UNITED NUCLEAR (HEMATITE), DOCKET 70-36, NOVEMBER 17, 1961

We have reviewed the proposed shipping container for structural integrity. Unfortunately, there are no firm regulations to follow, such as Part 72 for shipment of irradiated fuel elements. The Bureau of Explosives' requirements (File No. 25-16-17h, Revised Sept. 1, 1960) are not very specific; however, they specify that the container "must be so designed that it will maintain its efficiency even if subject to the effects of rather severe fire or impact". It is generally believed that railroad switching operations in classification yards cause the most severe damage to lading during rail shipment. Instrumented switching speed observations collected from a representative number of classification-yard operations indicated a mean impact velocity of 7 mph and a maximum as high as 10 mph. The corresponding impact forces on the container may be assumed, based on attached chart, to be about 23 G's and 35 G's respectively for the 7 and 10 mph impact speeds. It is suggested that an impact force of 30 G's be used in analyzing the important elements of these types of containers to insure required safety during shipment.

Suggested Improved Clamp Design

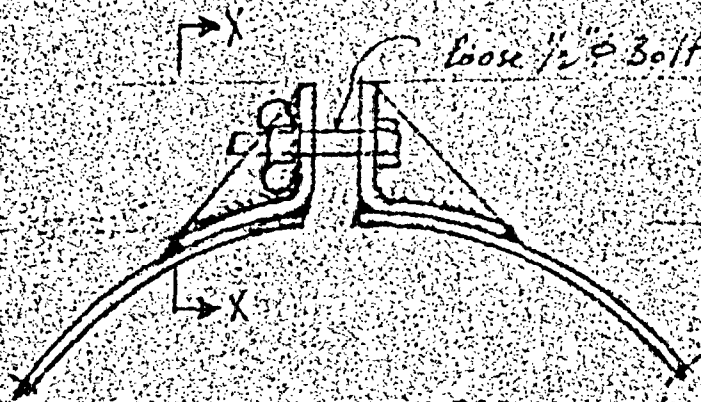
- c. The real weak part of the whole assembly is the clamp design. An impact force of less than 3 G's (in terms of the loaded drum) would tend to open up the flanged clamp. It is expected that due to a slightly higher impact force the strap would slip away from the wing-nut causing the drum to fly out of its hold. It is suggested that the design be improved and greatly strengthened.
- d. The hinges (HAGER #1811) are also considerably weaker in strength than desired. The hinge pin is calculated to fail in shear at only 7 G's, the strap in tension at about 13 G's. A stronger hinge should be used.

at root of Corner Brace

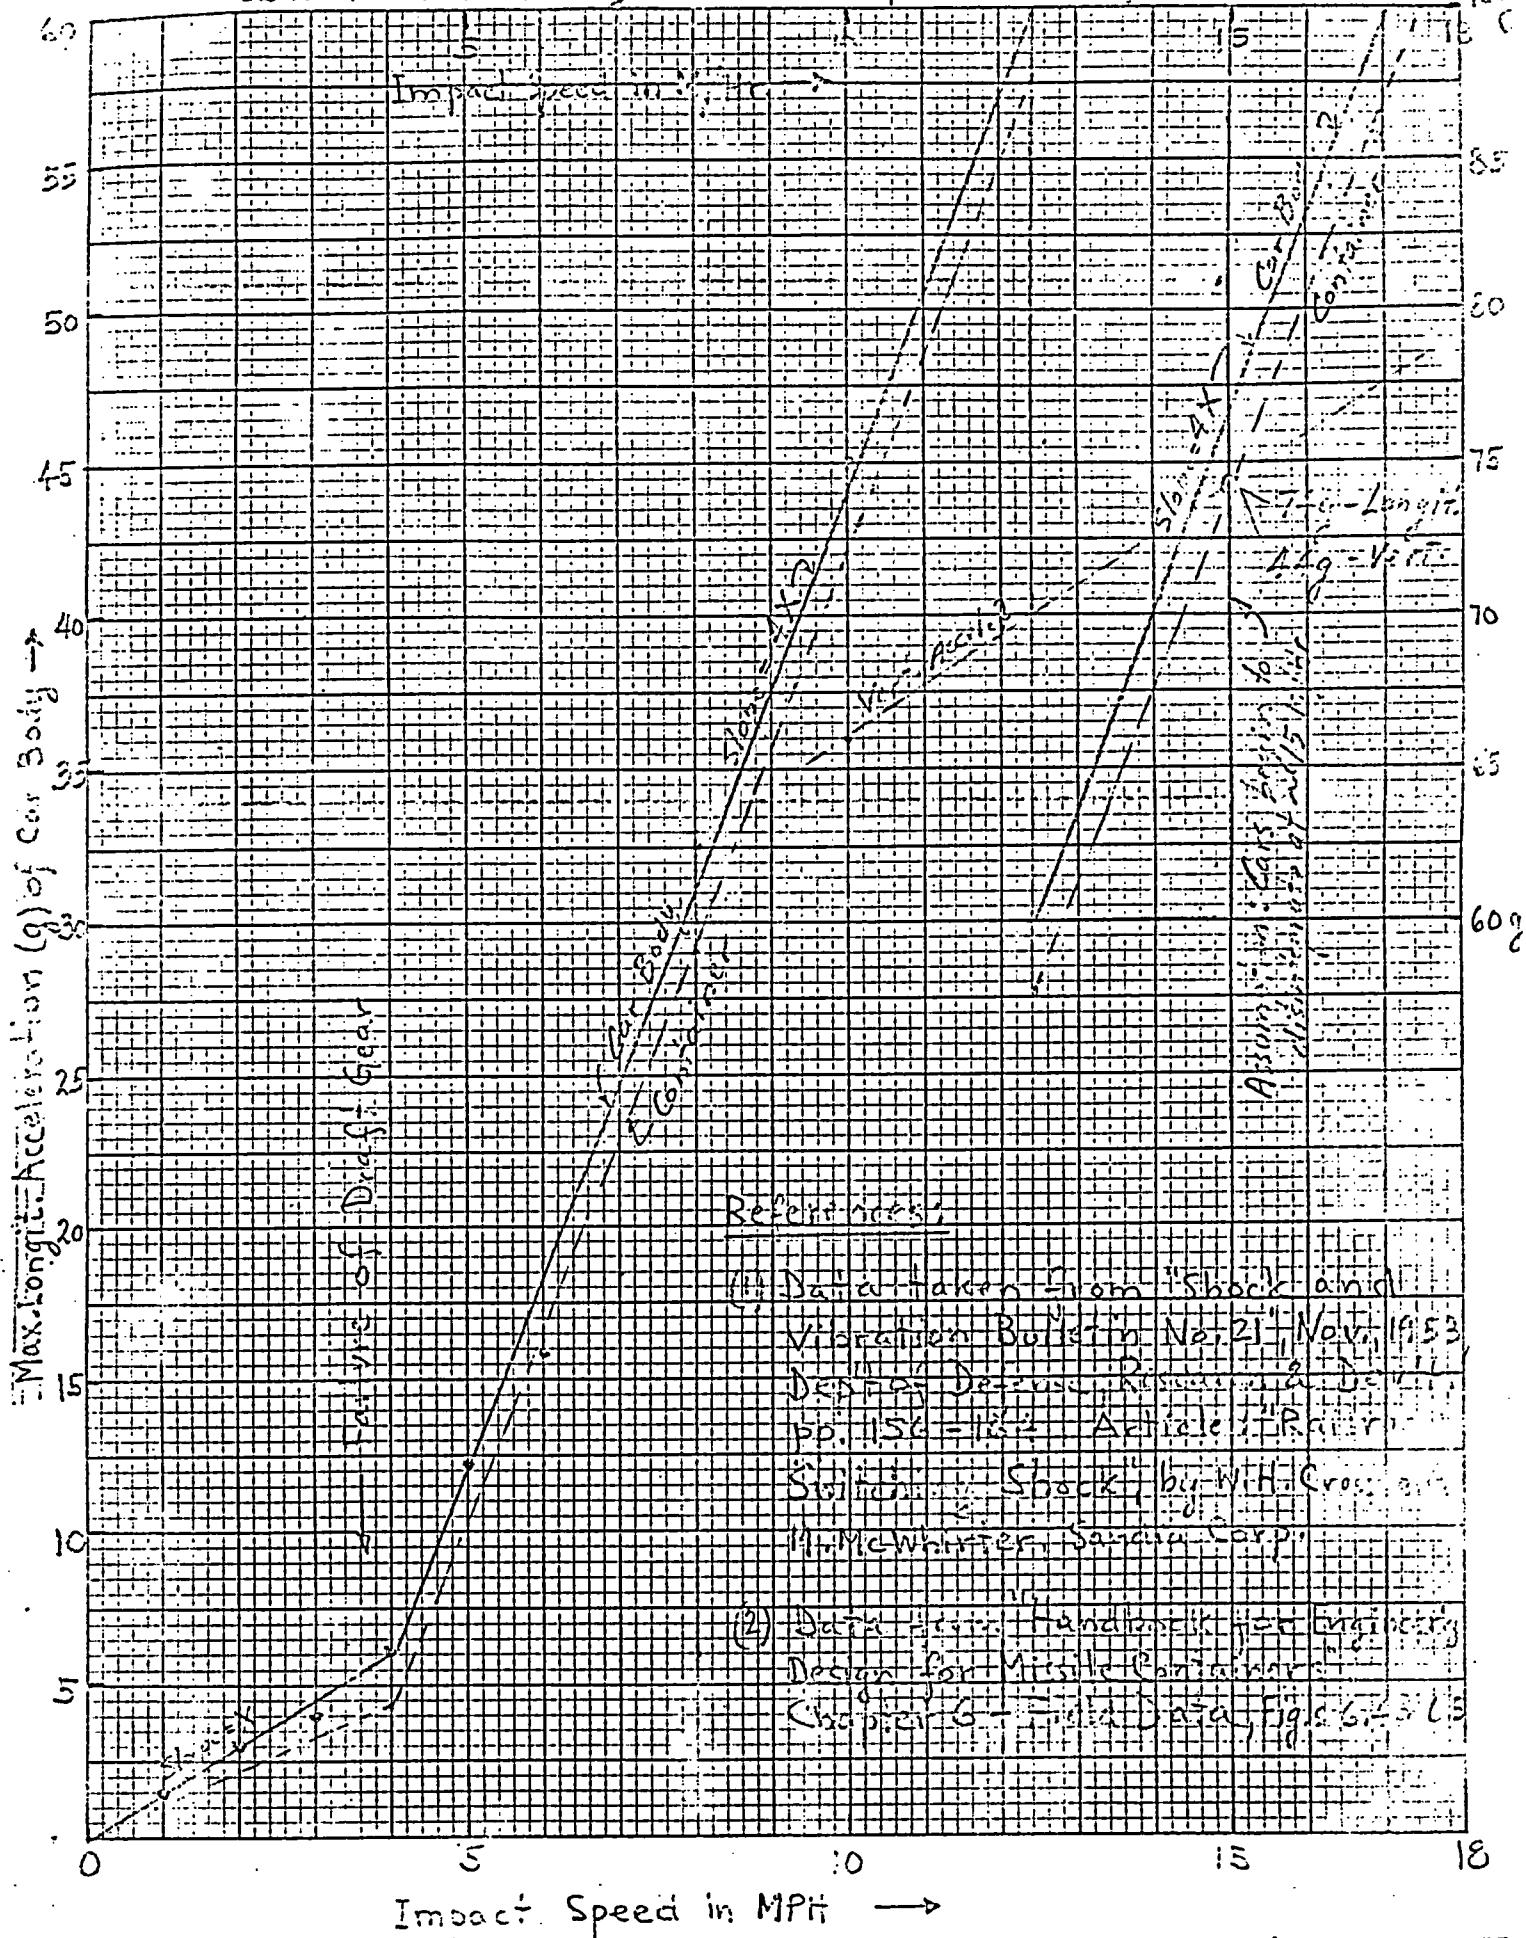
- a. The framework (birdcage) has sufficient strength to resist an impact force of about 100 G's without any appreciable yield and is, therefore, assumed entirely satisfactory, even for a corner impact.
- b. The strap attachment of the band to the angle frame will resist an impact force of about 2 G's if only the toes of the strap are welded. The detail as shown on the drawing of this connection is not clear. If the sides of the strap are also welded, the strength of the connection, in combined bending and shear, is calculated to resist an impact force in excess of the 30 G's.
